ECE/TRANS/WP.29/2009/46  
17 December 2008

Proposal for Corrigendum 2 to Revision 2 to Regulation No. 44  
(Child restraint systems)

Submitted by the Working Party on Passive Safety (GRSP) \*/

Figure 1

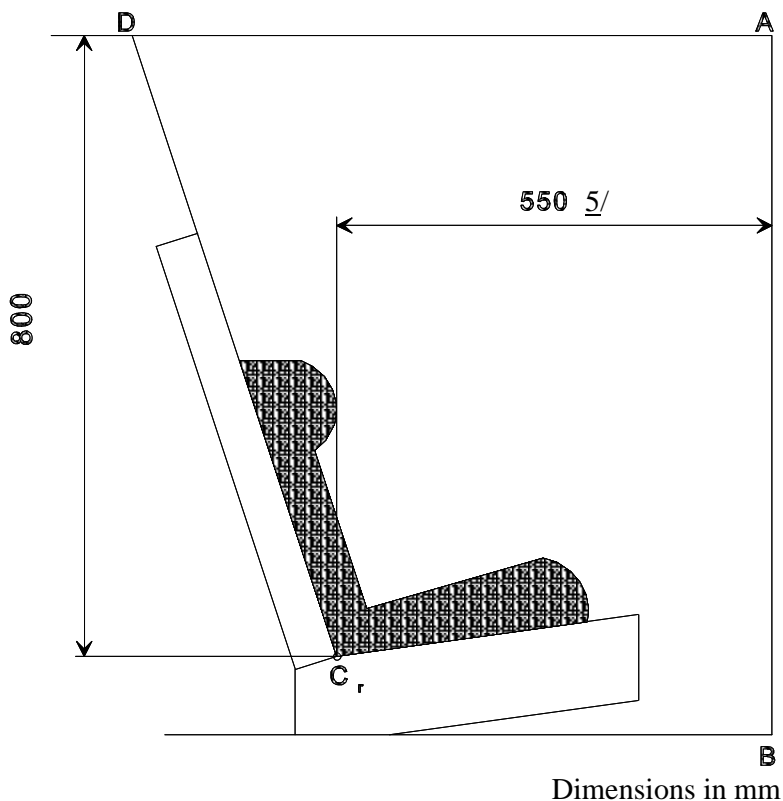
Paragraph 7.1.4.4.1.1., figure 1, insert a reference to a footnote 5/ to the 550 dimension, and insert the corresponding footnote 5/, to read:

5/ For the purpose of the test specified in paragraph 7.1.4.1.10.1.1., this dimension shall be 500 mm."
